**TOWN OF MOUNTAIN VILLAGE  
SPECIAL DESIGN REVIEW BOARD MEETING  
TUESDAY, MAY 31, 2022 10:00AM  
MOUNTAIN VILLAGE TOWN HALL  
455 MOUNTAIN VILLAGE BLVD, MOUNTAIN VILLAGE, COLORADO  
TO BE HELD HYBRID THROUGH ZOOM:**

**RE:** Staff Memo – Review and Recommendation to Town Council Regarding a Major Planned Unit Development Amendment to the Lot 109R Planned Unit Development, commonly called the Mountain Village Hotel PUD, by Tiara Telluride, LLC.

**APPLICATION OVERVIEW: Mixed Use Development inclusive of a hotel, condominiums, lodge units and employee housing on Lot 109R**

DIAGRAM - PEDESTRIAN AND BIKE CIRCULATION  
1 1" = 20'-0"

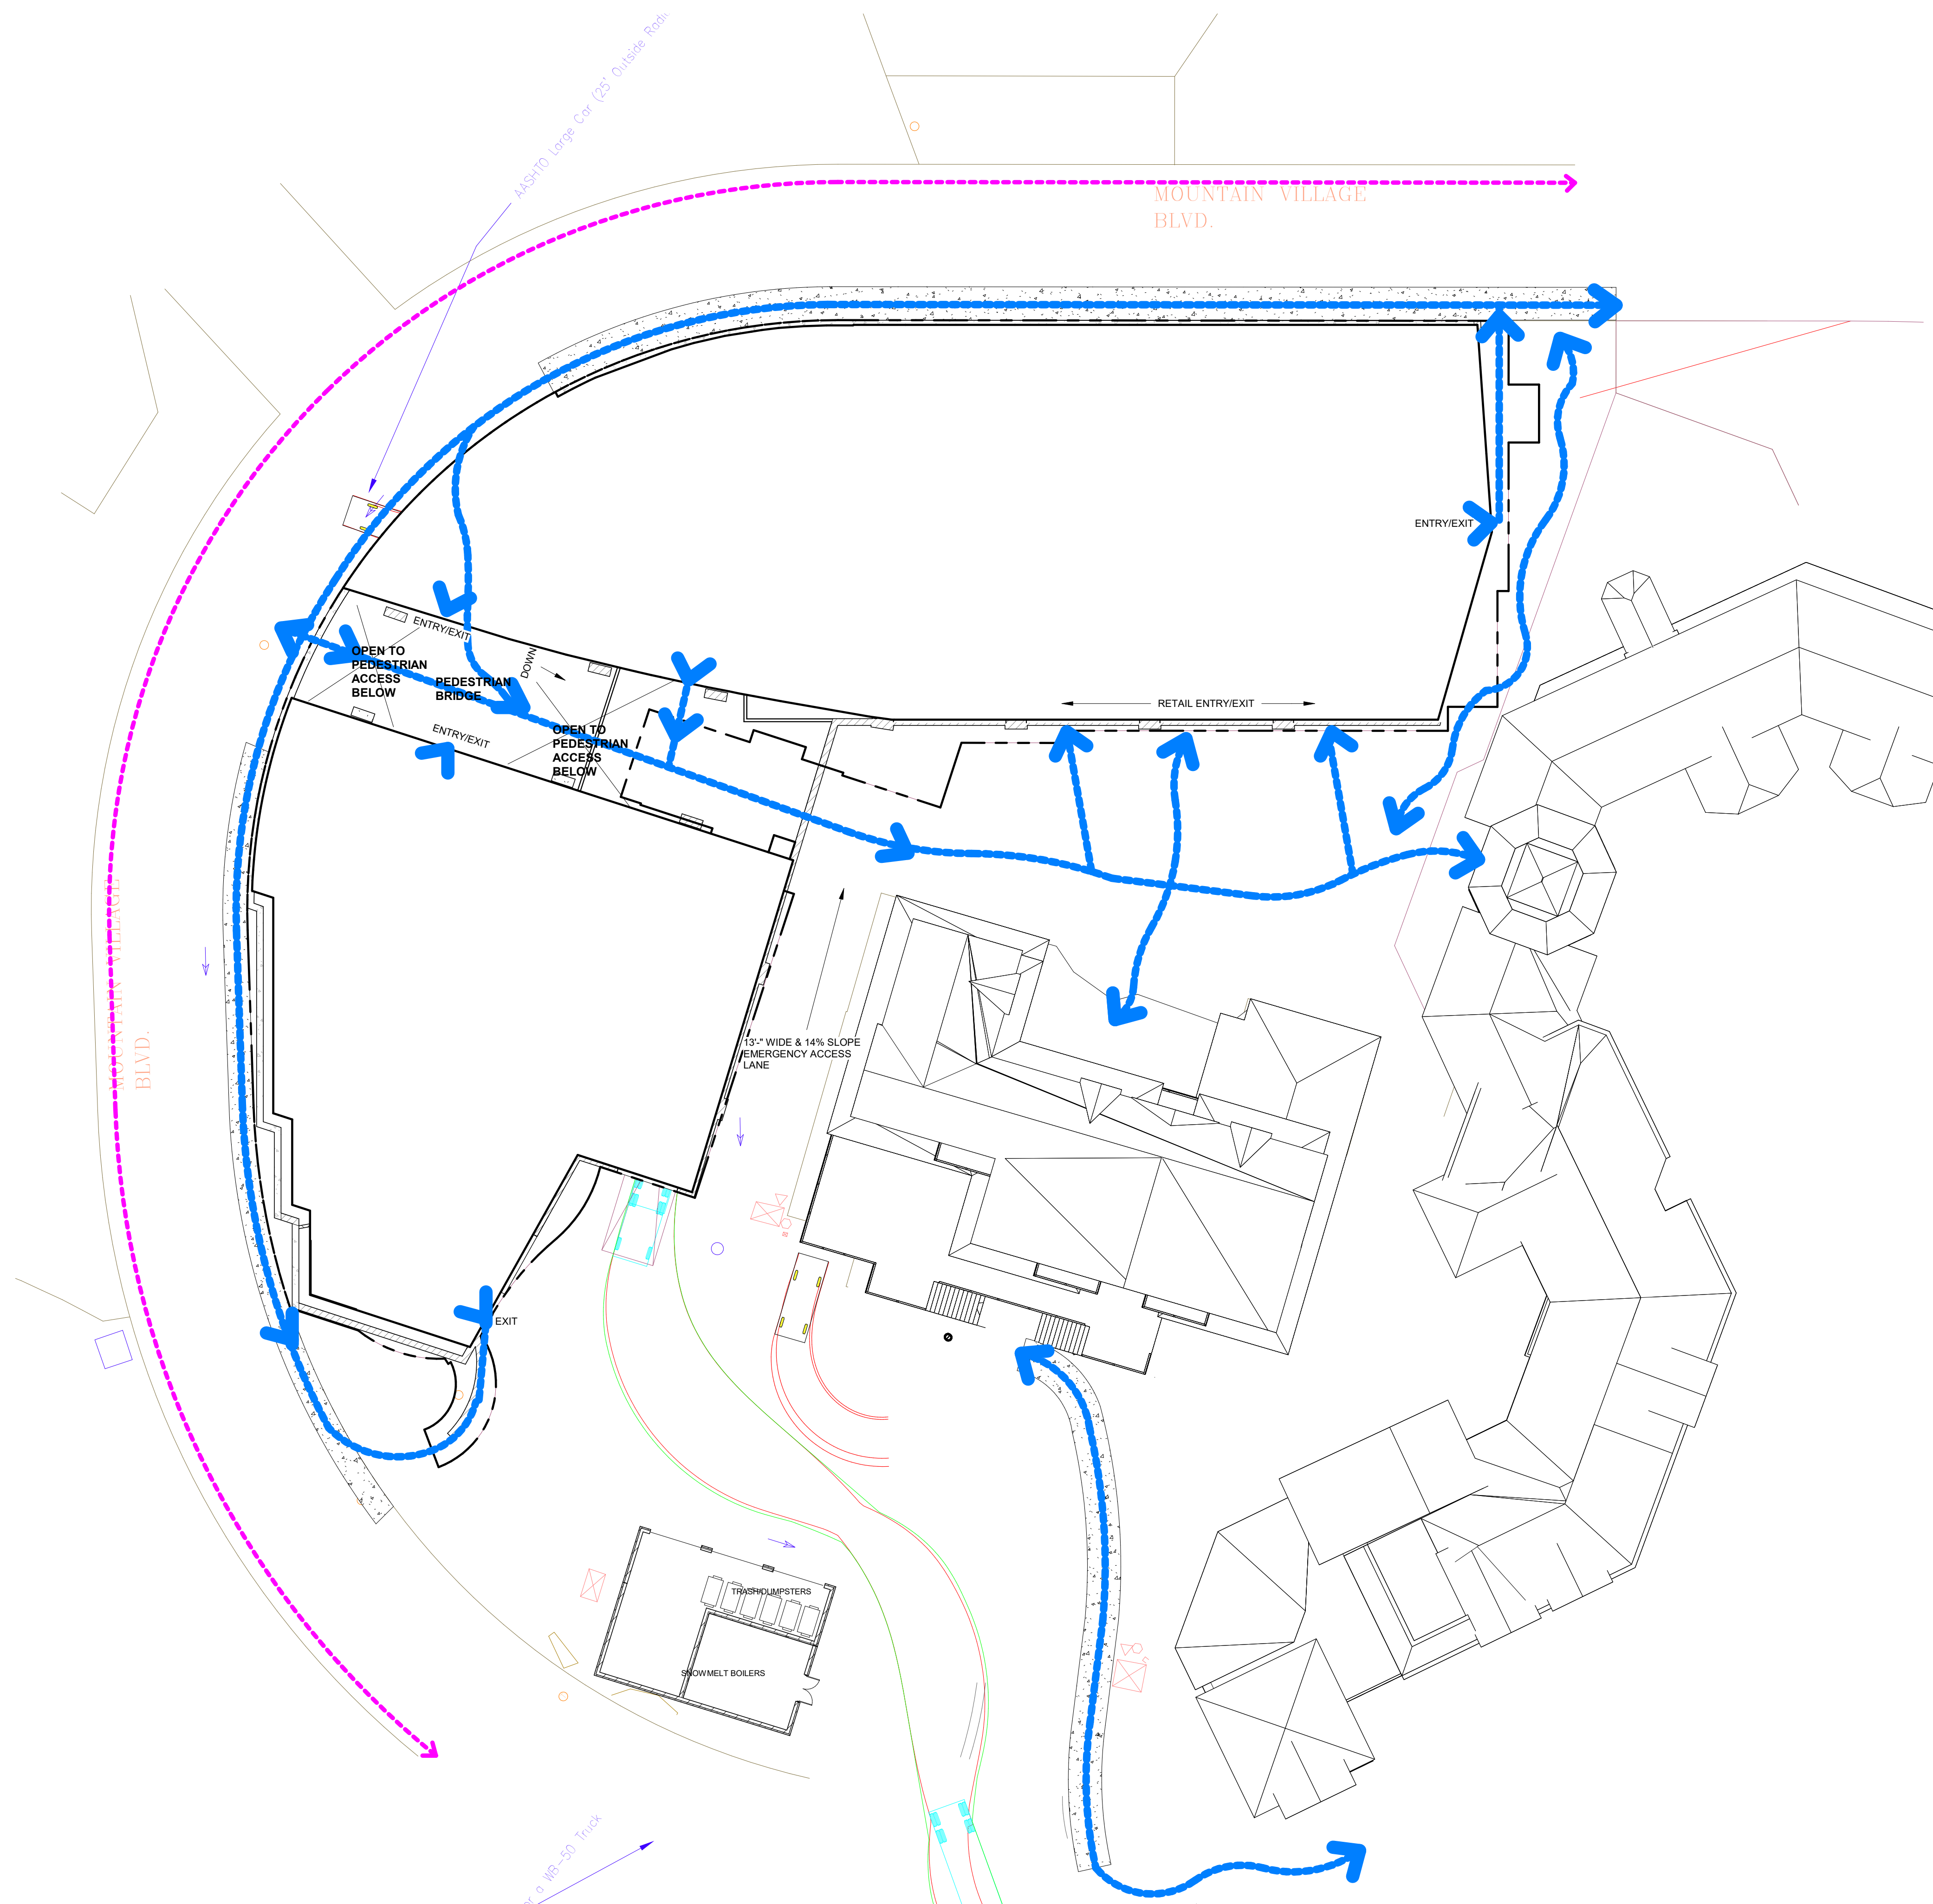
*The building frontage should contain and direct pedestrian traffic fairly well, with the exception of the potential for pedestrians to head west on the emergency lane toward Mountain Village Boulevard. The applicant has proposed a new sidewalk from the Shirana Stairs towards the Peaks crosswalk area. Although some will likely walk through the Shirana building as indicated on the pedestrian circulation plan, some will inevitably follow*

The applicant has also added a sidewalk along mountain village boulevard. As currently shown, there is a break in the sidewalk at the See Forever tunnel/vehicular bridge. The intention is that the sidewalk is continuous on Mountain Village Boulevard and necessary for ADA access from the town's perspective. The applicant proposed this revised sidewalk all along Mountain Village Boulevard which will create safe pedestrian access from the 161CR/Pond lots site (pursuant to their sketch approval) to the crosswalk that serves the Peaks, being provided by the 109R proposed project plan.

**RESPONSE: Please see pedestrian and bicycle circulation diagram on sheet A2.08. Please see WB-50 delivery truck, garbage truck, fire truck/ambulance and golf cart service access on sheet A2.09.**
